#### HISTORIC AND DESIGN REVIEW COMMISSION

March 16, 2022

HDRC CASE NO: 2022-147 ADDRESS: 114 BOSTON

**TYPE OF WORK:** Construction of a rear and side addition

A1.0

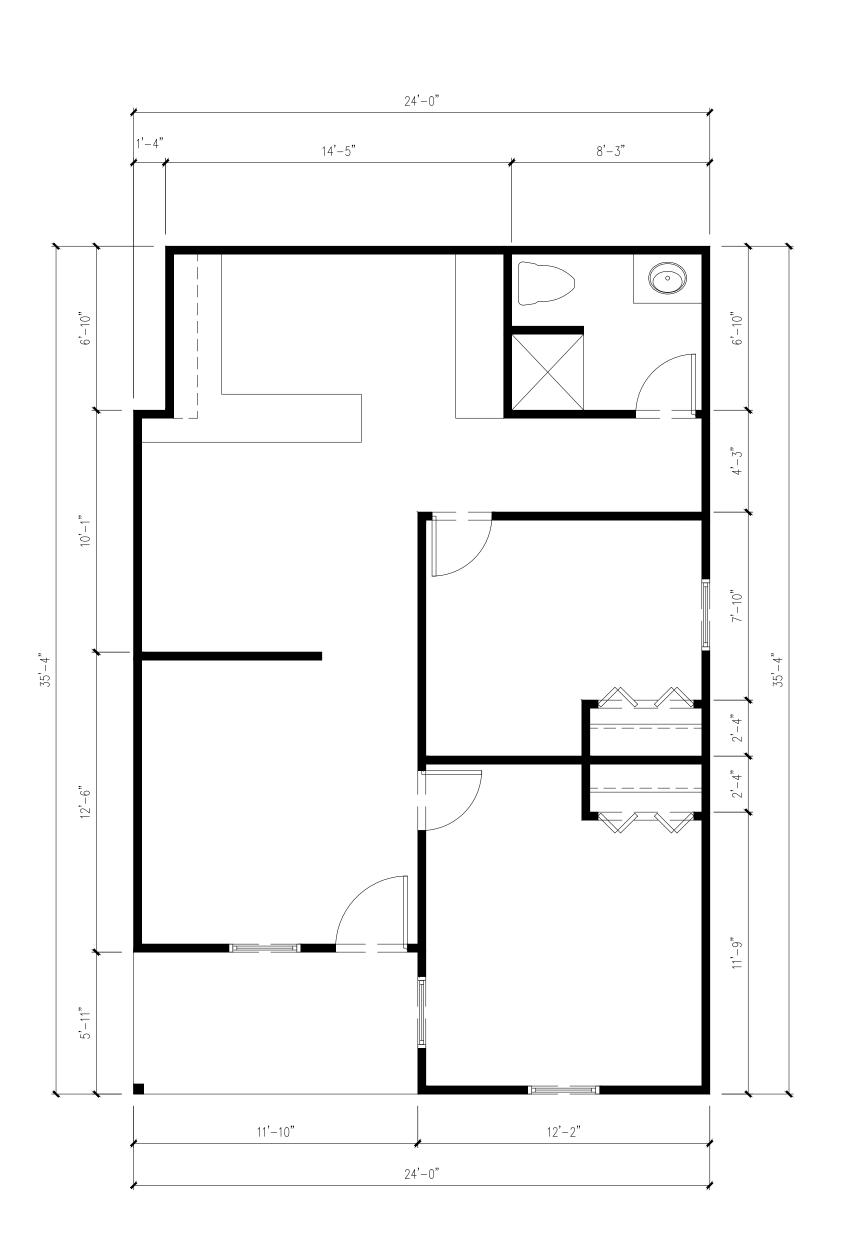
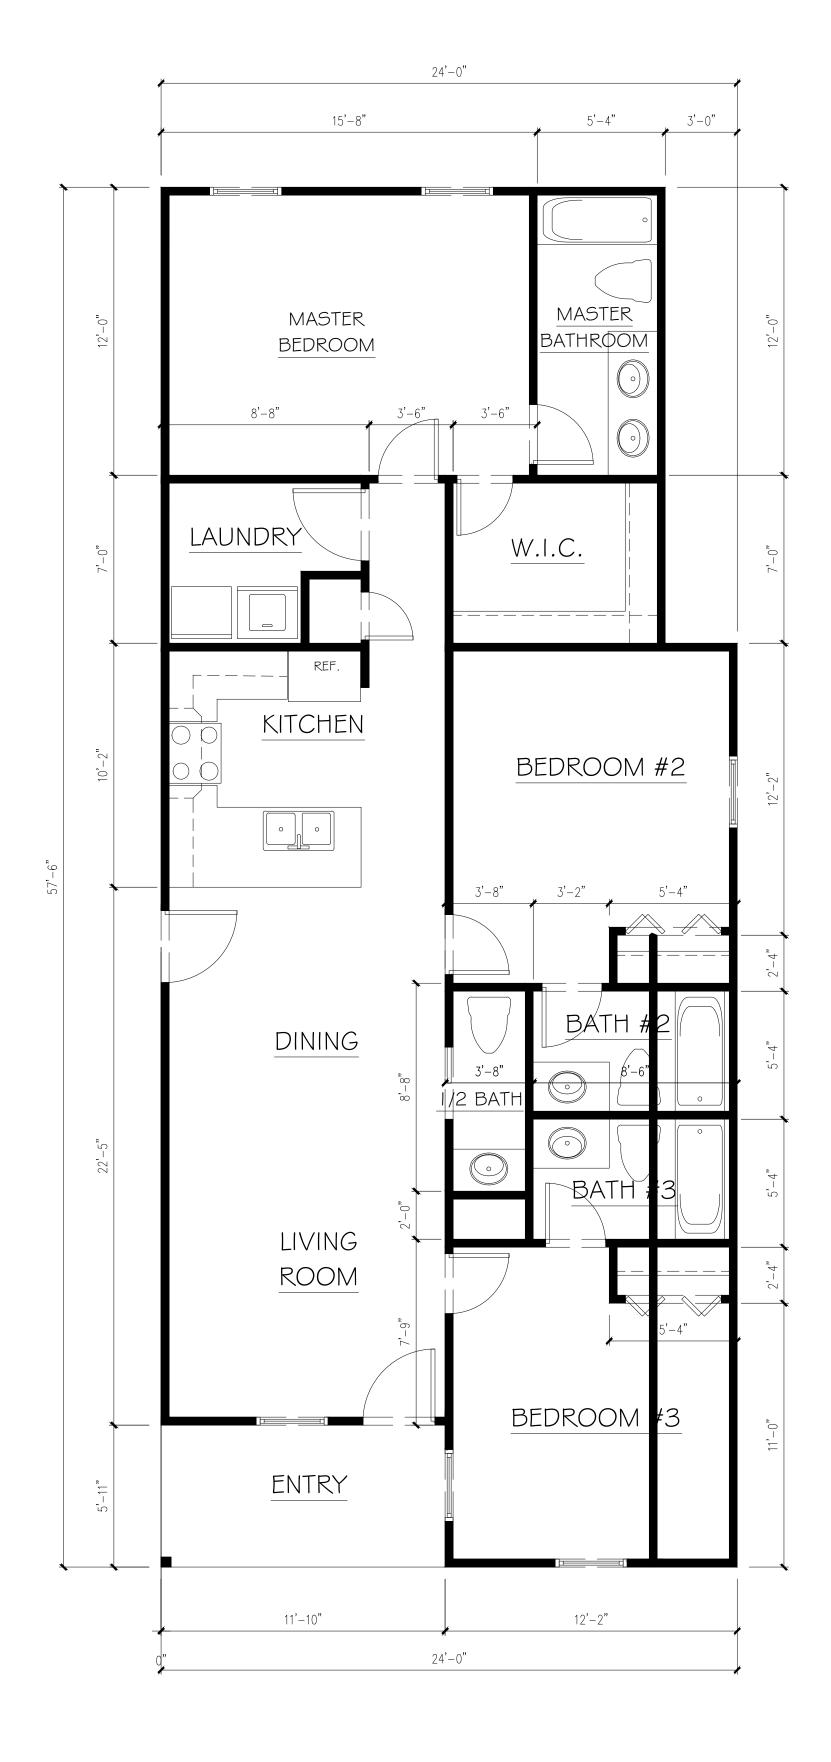
- i. WALKWAY The applicant has proposed to replace the existing concrete walkway with a new concrete walkway. The existing concrete walkway is damaged and staff finds its replacement to be appropriate; however, staff finds that the existing profile should be maintained, including the flare at the front porch steps.

- j. DRIVEWAY The applicant has proposed to install a new ribbon strip driveway where an existing ribbon strip driveway exists. The Guidelines for Site Elements note that new driveways should feature a similar configuration as those found historically within the district in regards to their materials, width and design. Staff finds the keeping of the ribbon strip profile to be appropriate. The driveway should not exceed ten (10) feet in width, per the Guidelines.

- 2. Staff recommends approval of item #2, the replacement of the existing concrete walkway provided that it is replaced in-kind, with a matching profile, based on finding h. This is to include the exiting flare.

- 3. Staff recommends approval of item #3, the installation of a new ribbon strip driveway provided that it features no more than ten (10) feet in width.

A4.0

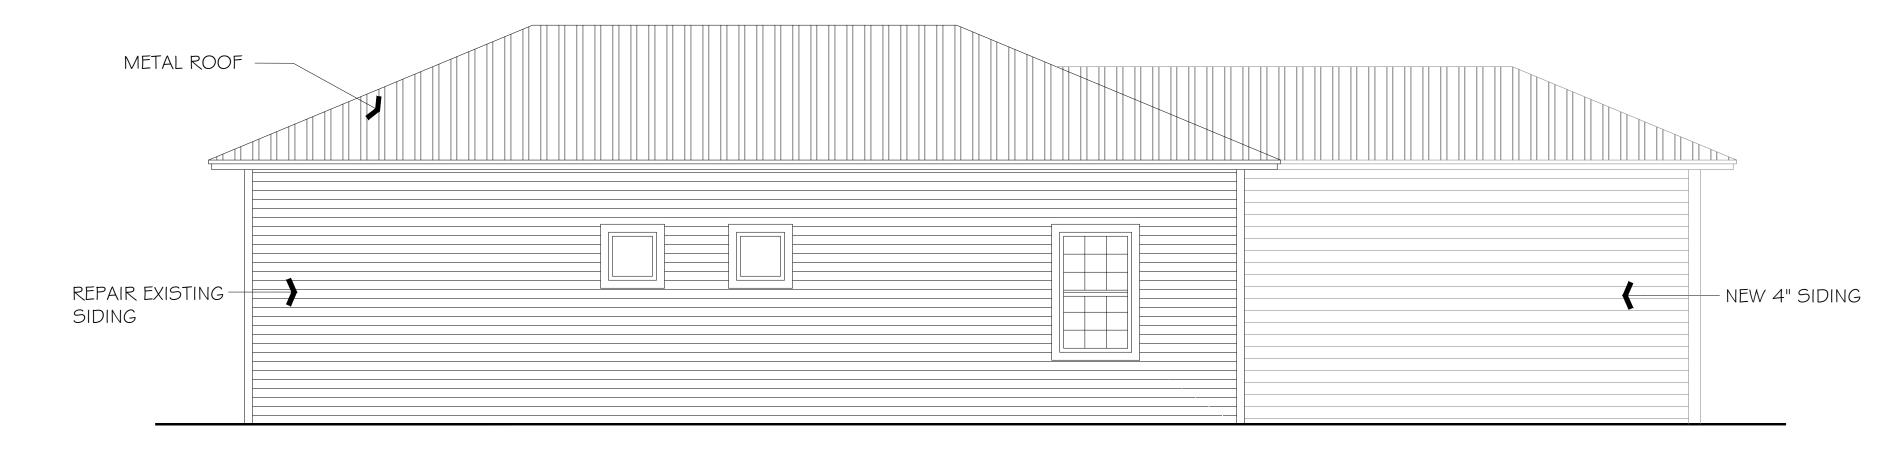
- d. FENESTRATION MODIFICATIONS The applicant has proposed to remove existing window openings from both the east and west facades of the historic structure. The Guidelines for Exterior Maintenance and Alterations notes that existing window and door openings should be preserved. Staff finds the removal and modification of existing window openings as well as the creation of contemporarily sixed window openings to be inappropriate and inconsistent with the Guidelines.

- f. ADDITION (Materials) The applicant has proposed materials that include a standing seam metal roof, and new siding with a four inch exposure. Generally, staff finds the proposed siding and metal roof to be appropriate. If composite siding is used, it should feature a smooth finish and four inch exposure. If wood siding is used, it should feature a 117 profile to match the siding of the original structure.

- g. ADDITION (Windows) At this time, the applicant has not specified window materials for the proposed addition. Staff finds that wood or aluminum clad wood windows should be installed to be consistent with staff's standard specifications for windows in new construction. Staff finds that window openings should be added to both the east and west facades.

- h. ADDITION (Architectural Details) The Guidelines for Additions 4.A. notes that additions should be designed to reflect their time while respecting the historic context of the historic structure and should incorporate architectural details that are consistent with those of the original structure. Generally, staff finds the architectural elements to be appropriate; however, staff finds that additional window fenestration should be added to both the east and west facades. Fenestration should be consistent with that found historically within the historic structure.

- 1. Staff recommends approval of item #1, the construction of a rear addition with the following stipulations:
  - i. That the applicant install either composite siding with the 4 inch exposure and smooth finish or 117 profile wood siding.

- ii. That the applicant install additional window fenestration and window openings in both the east and west facades.
  - iii. That the applicant install wood or aluminum clad wood windows that are consistent with staff's standards for windows in additions and new construction.

- 4. Staff recommends approval of item #4, siding repair, based on finding c.
- 5. Staff does not recommend approval of item #5, modifications to historic window openings and the creation of additional window openings in the historic structure. Staff recommends all existing window and door openings be preserved as they exist.
